## **Addendum #2**

**Bid Opportunity: 7251-RW-22**

### **Waterloo Oxford District Secondary School - Family Studies Renovation & HVAC Upgrades**

**A3.2R**

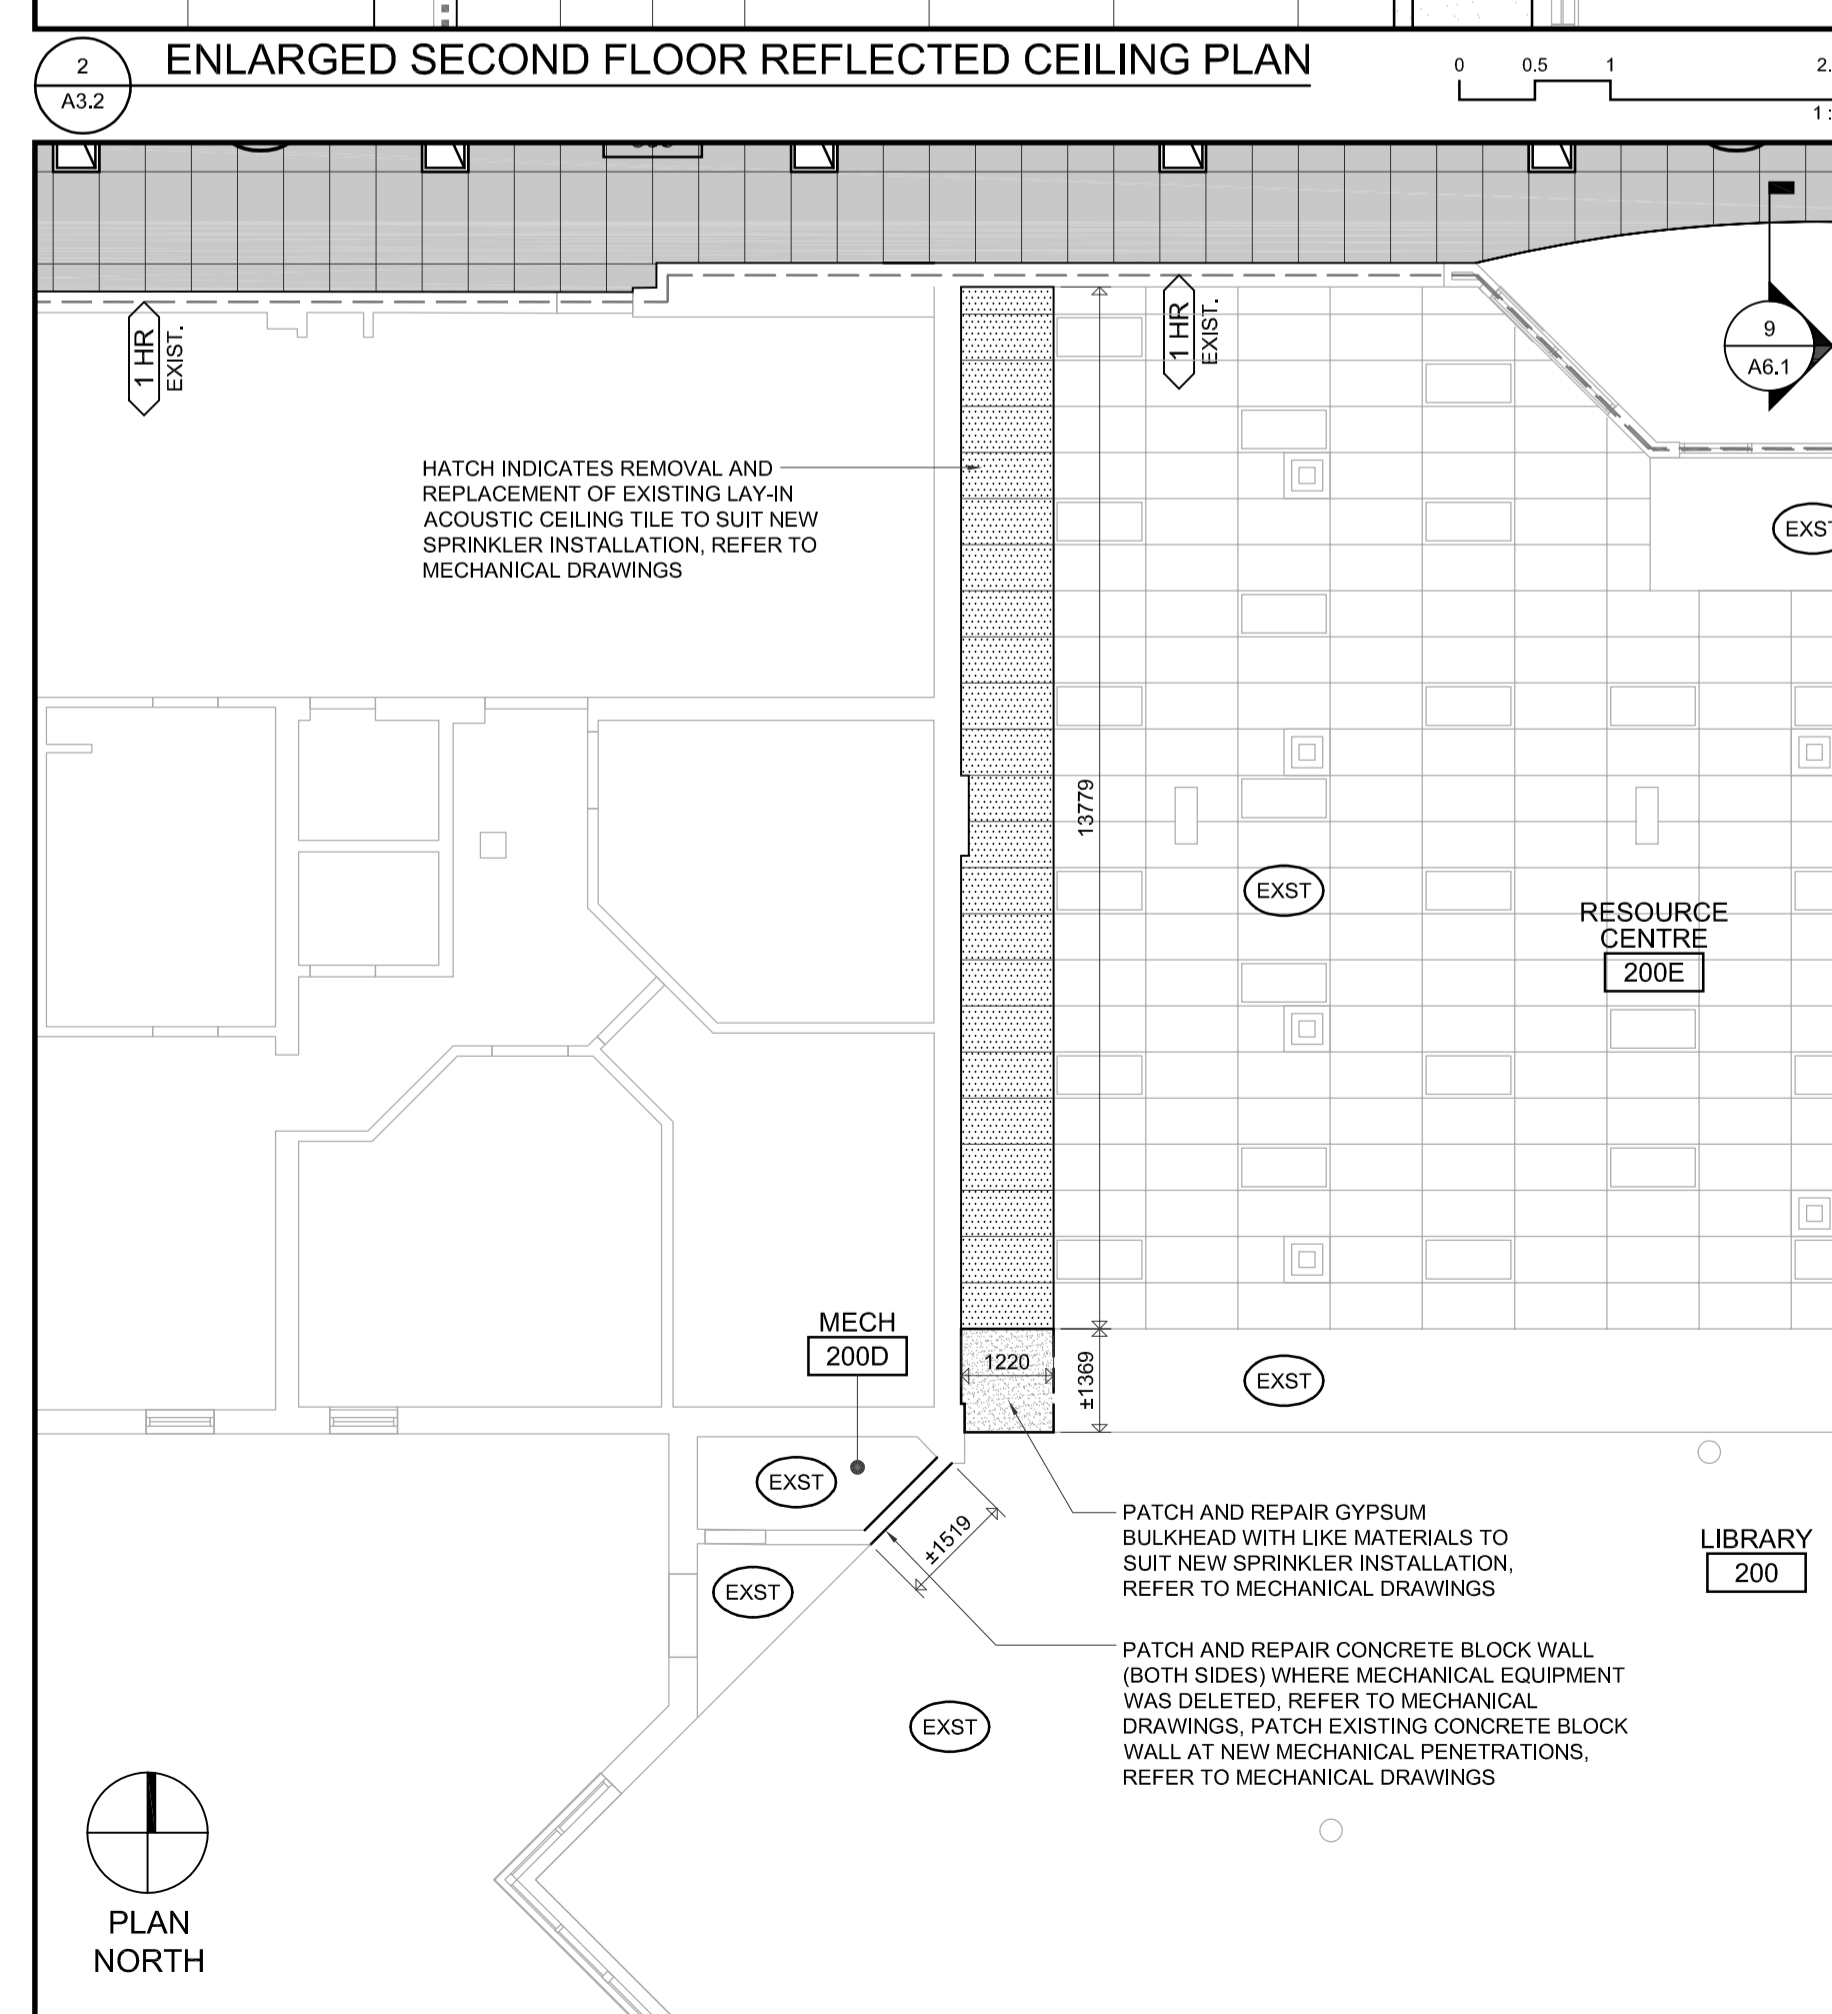
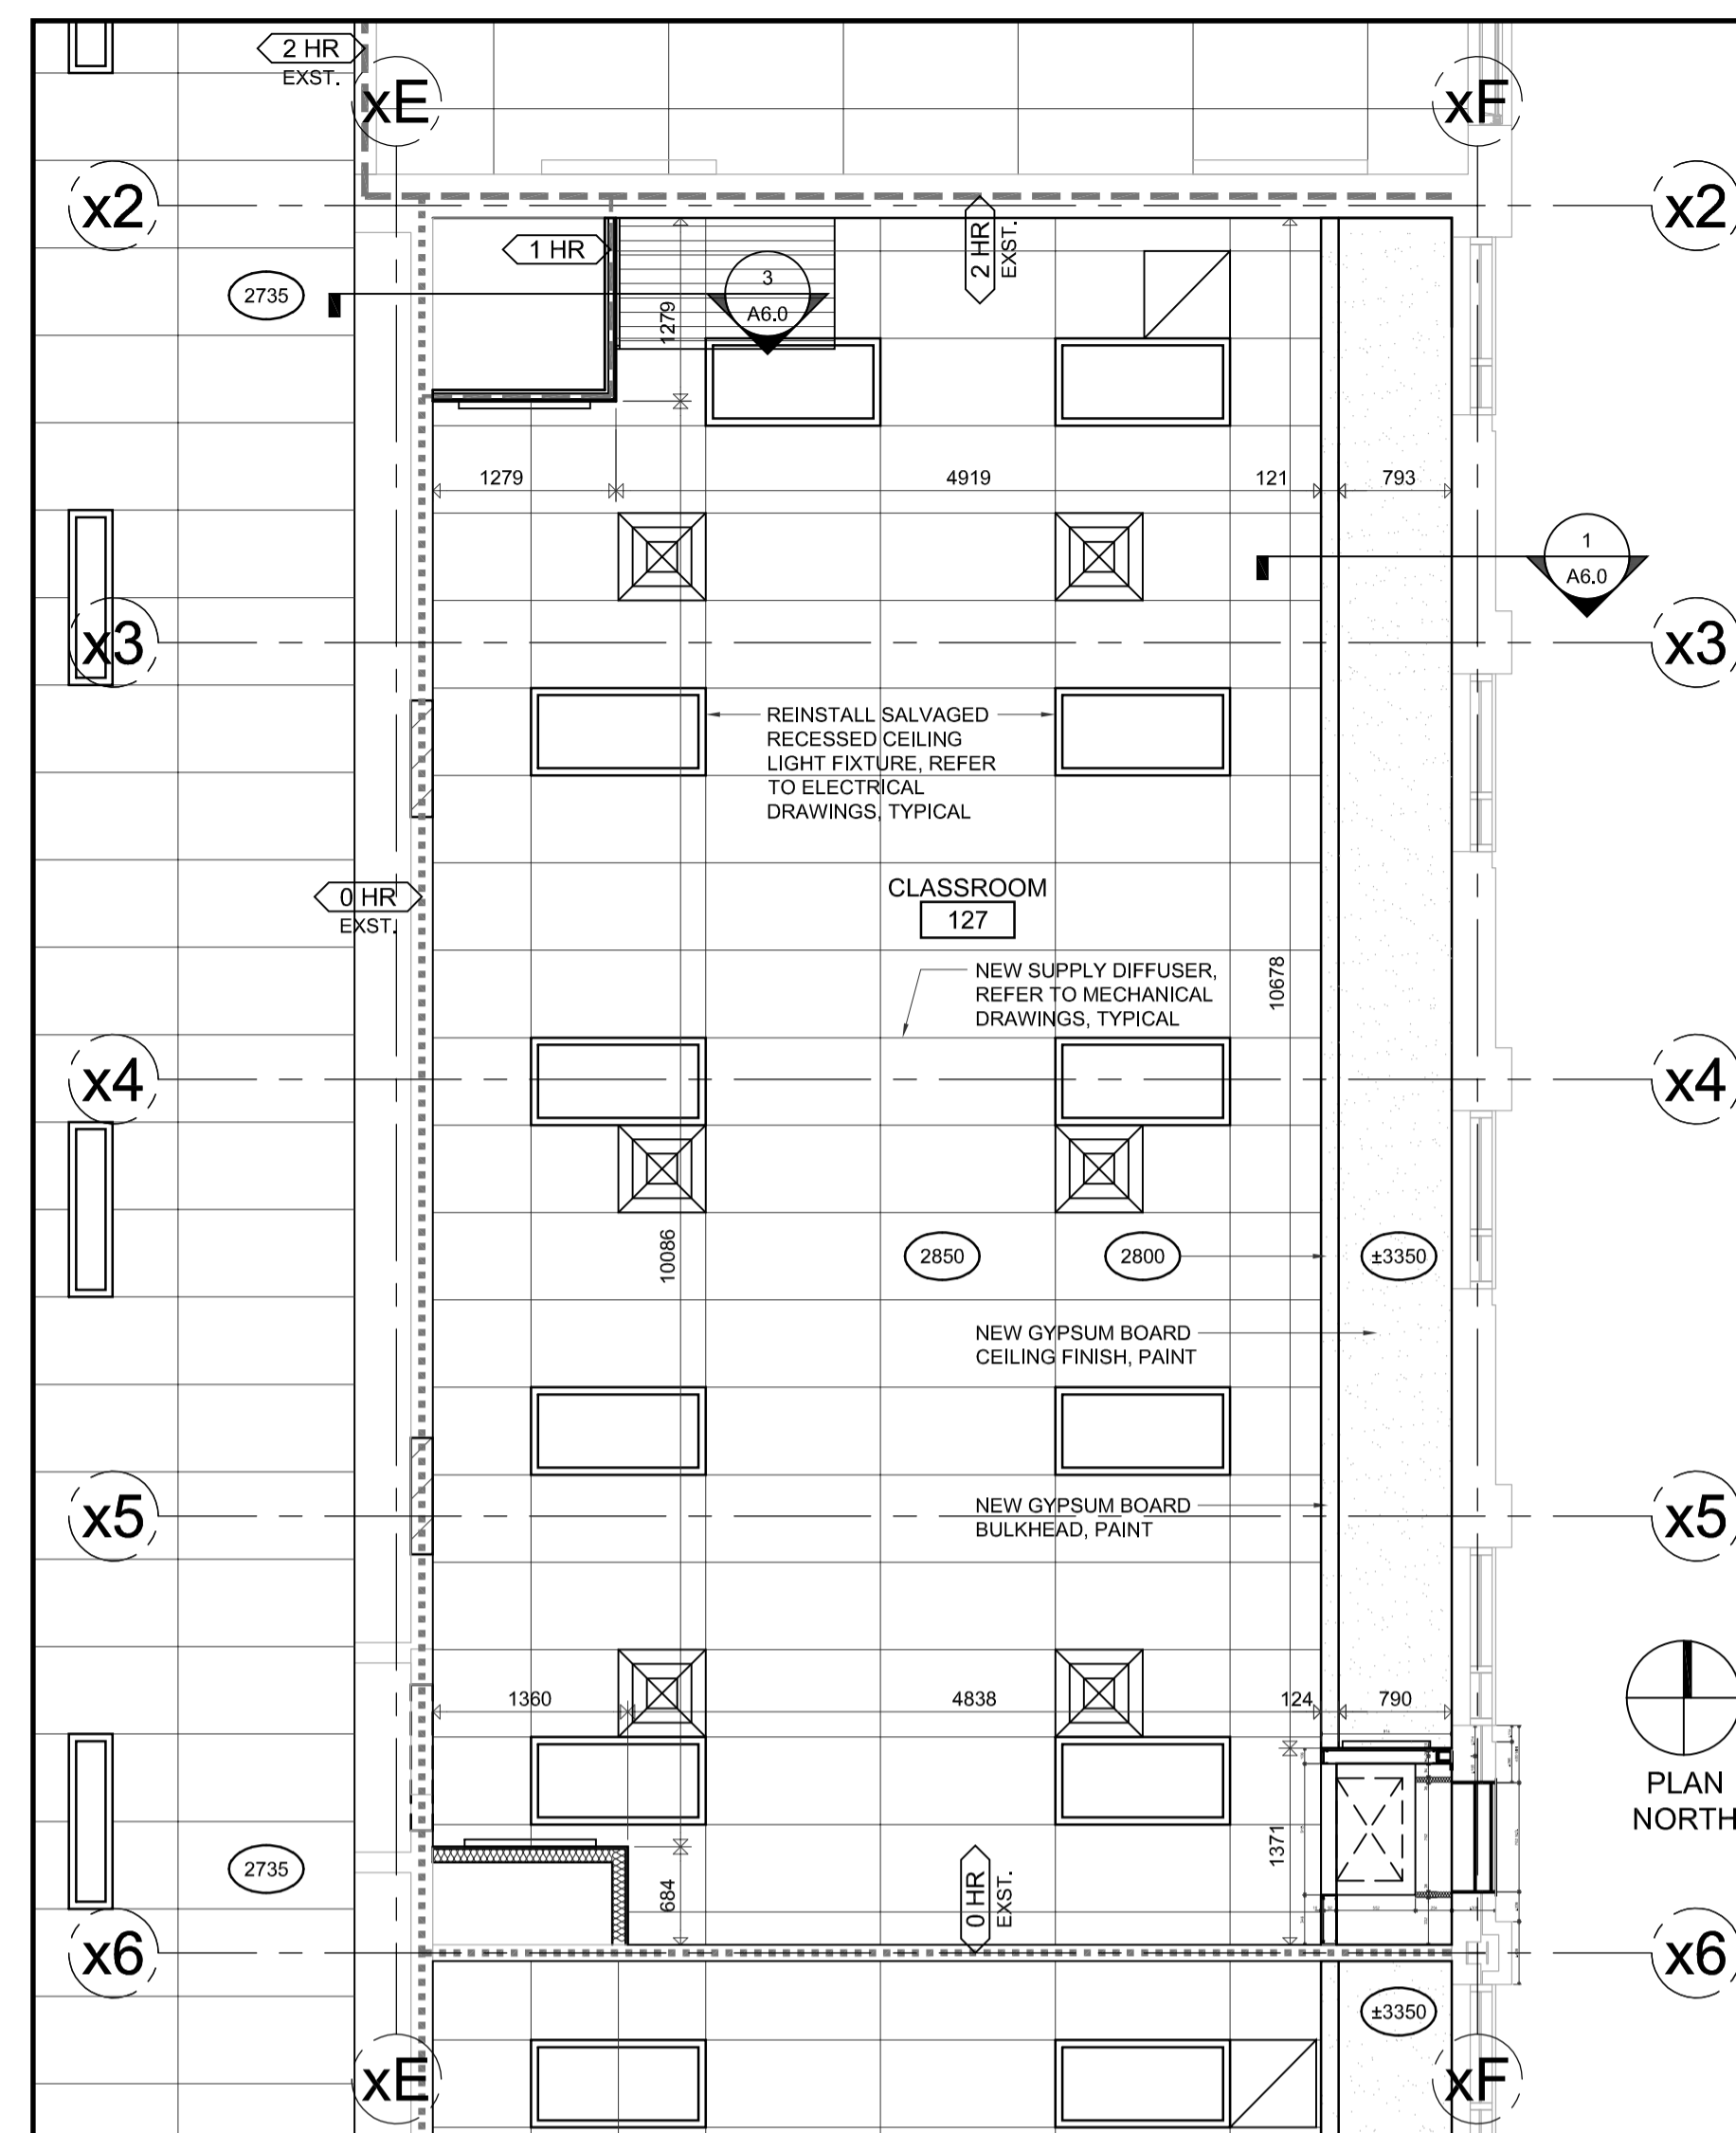
6. Drawing A3.2 Partial and Enlarged Reflected Ceiling Plans
  1. **REPLACE DRAWING A3.2 WITH DRAWING A3.2R, ATTACHED.**
    1. **1/A3.2 REVISED TO SHOW ADDITIONAL BULKHEADS.**
